Subject : Power plant ignition system

Effectivity type: DG-800
Variants: DG-800 A all serial numbers
DG-800 LA all serial numbers

Modification of the powerplant – ignition unit to Ducati 432372501 ignition electronic boxes

Picture 2

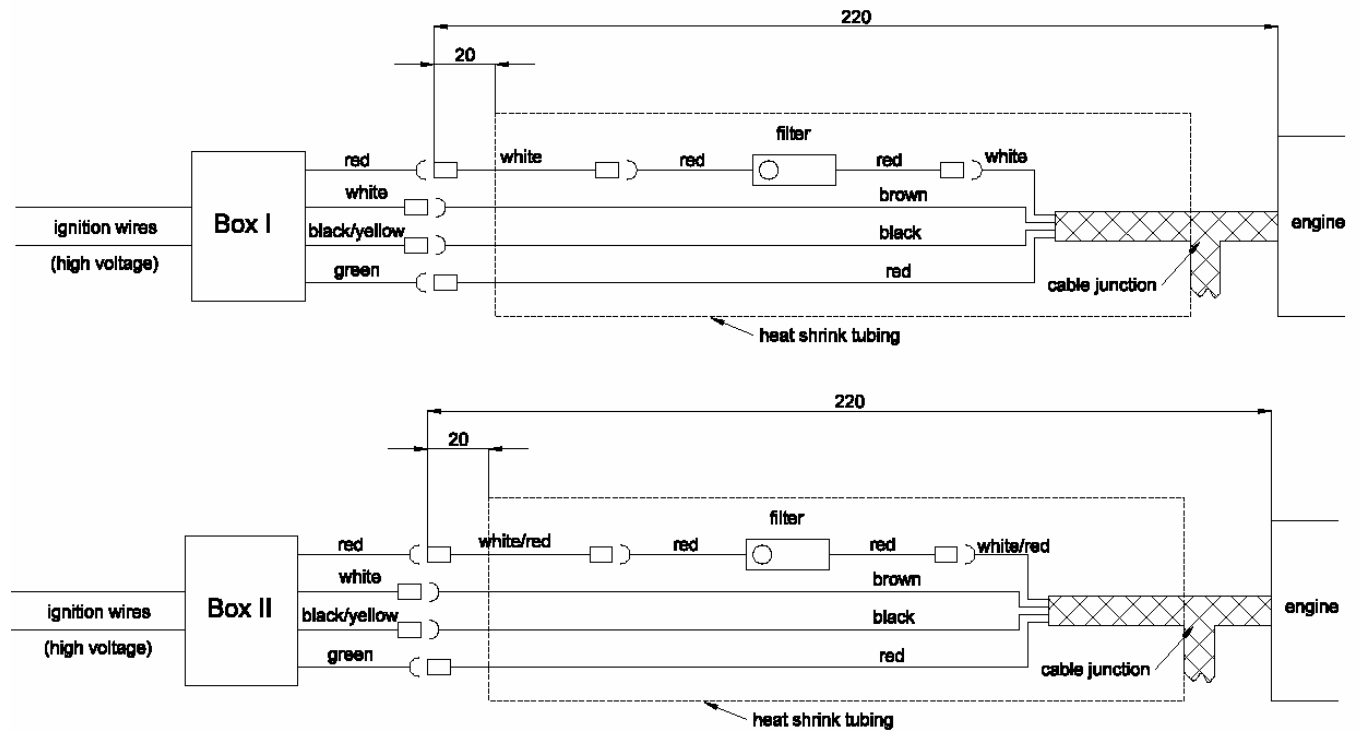
1. Open the cable harness from the ignition boxes up to the cable junction (pic.2 and sketch 2). The wires coloured white, brown, black and red are for ignition box 1 and white/red, brown, black and red are for ignition box 2.

2. Cut the white and the white/red wire 40 mm (sketch 2 detail Z) in front of the junction of the cable harness (pic.2). Slip pieces of heat shrink tubing over the shortened wires, crimp one spade connector (female) to each of the wires and shrink the tubing.

3. Plug an ignition box filter (pict. 1) to each of the two cable shoes. Slip heat shrink tubing over the connections and shrink the tubing. Take care of the correct mounting direction. (see pict.2).

4. Crimp a spade connector (male) on each of the wires remaining from point 2. Connect the wires according to pict.2 to the filters, so that you have the same wire colours as on the other side of the filter.

5. The cable harness for the ignition box aft (BOX II) has to be shortened to 300mm (pic.2). The cable harness for the front ignition box (BOX I) has to be shortened to 220mm (sketch 2 and pic.2). Slip heat shrink tubing over the cable harness as indicated in picture 2 and shrink the tubing. Note: 20mm of the wires must not be covered by the heat shrink tubing see pict.2.

6. Crimp cable shoes to the wires according to pict.2
7. Connect the wires to the ignition boxes according to pict.2.
8. Slip heat shrink tubing over every connection.

Picture 5

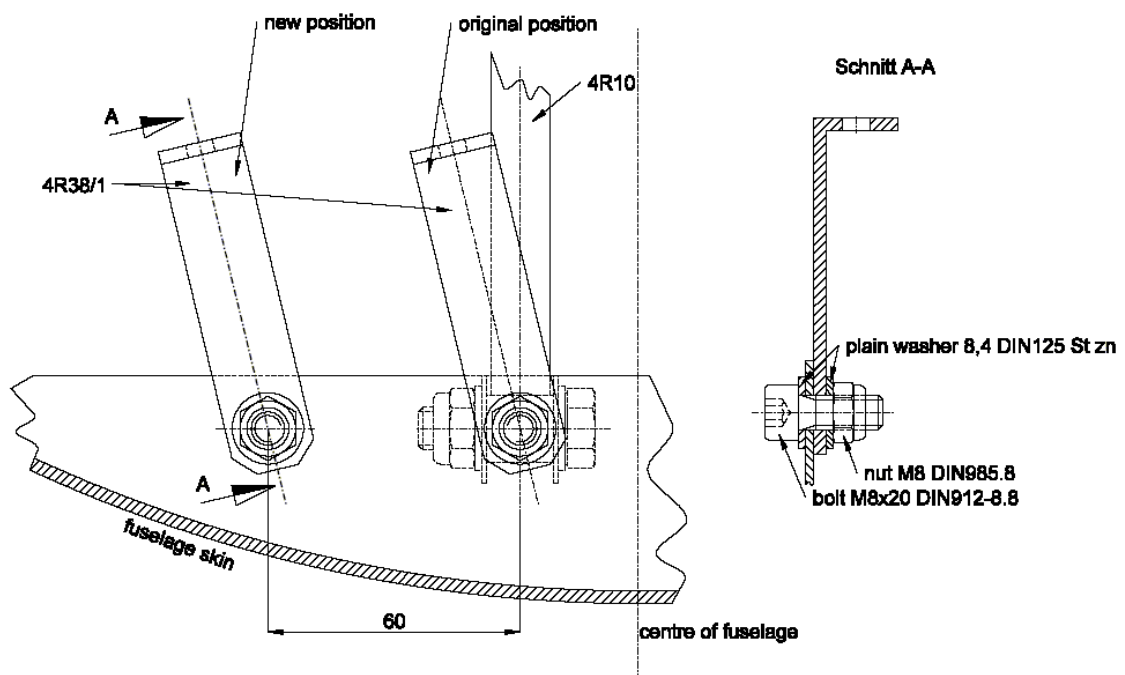
9. Cover the cable harness completely with heat shrink tubing.
10. The cable harness has to be fixed. The cable harness should not be able to vibrate or rub. Fix the cable harness according to pic3, 4 and 5 and drawing 4M77. The ty-raps have to be tightened by hand as tight as possible.

| | | | | | Maßstab | Änderung der Verkabelung für Ducati Elektronik Zündboxeb 432372501 Modification of the wiring for Ducati electronic ignition boxes 432372501 |  4E30 | |

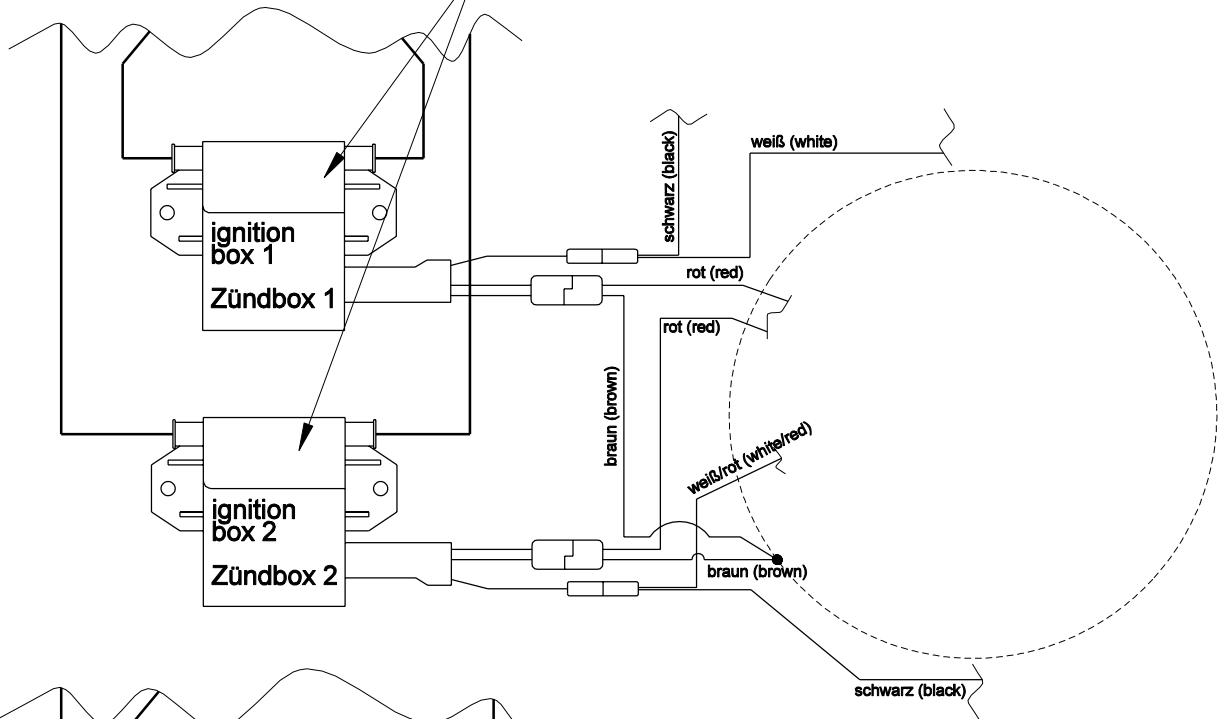
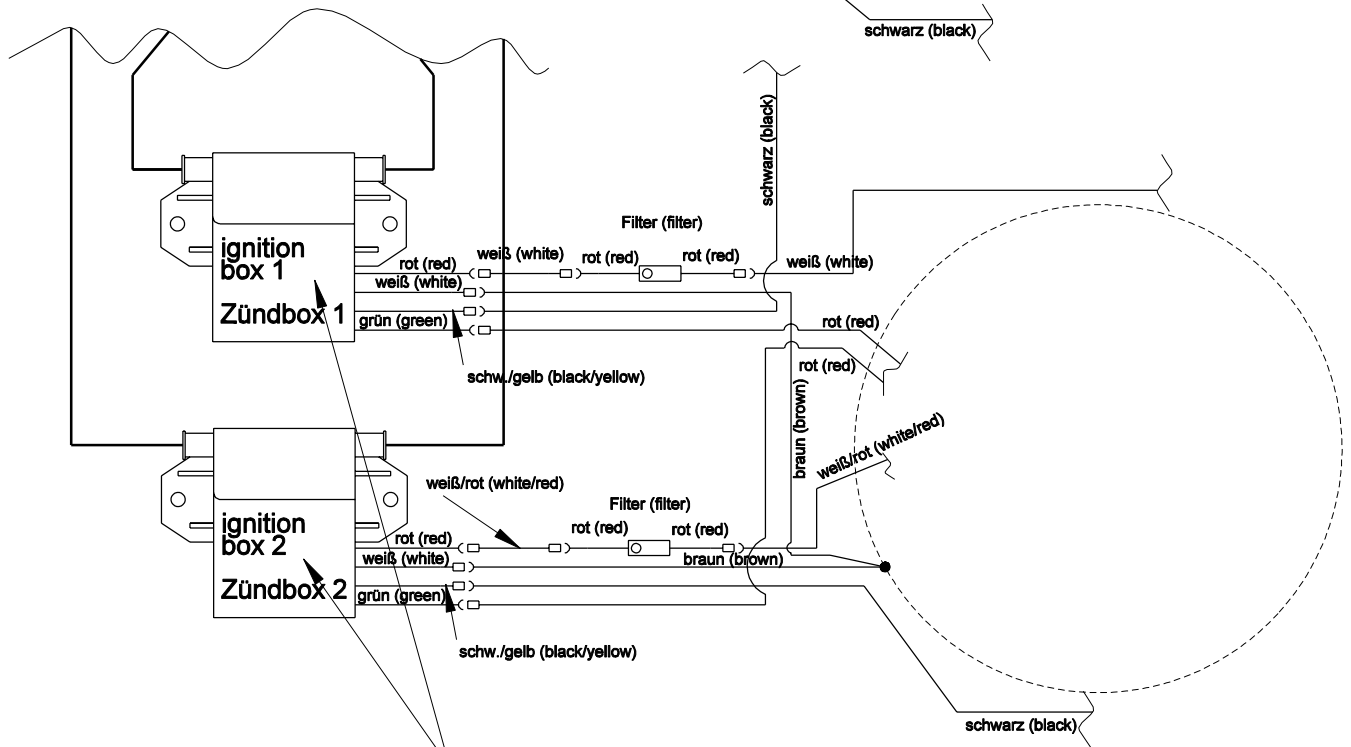
alt
old

neu
new

Zusatz zu Seite 16 Motorhandbuch Rotax 505
amendment to page 16 of the Rotax 505 engine manual
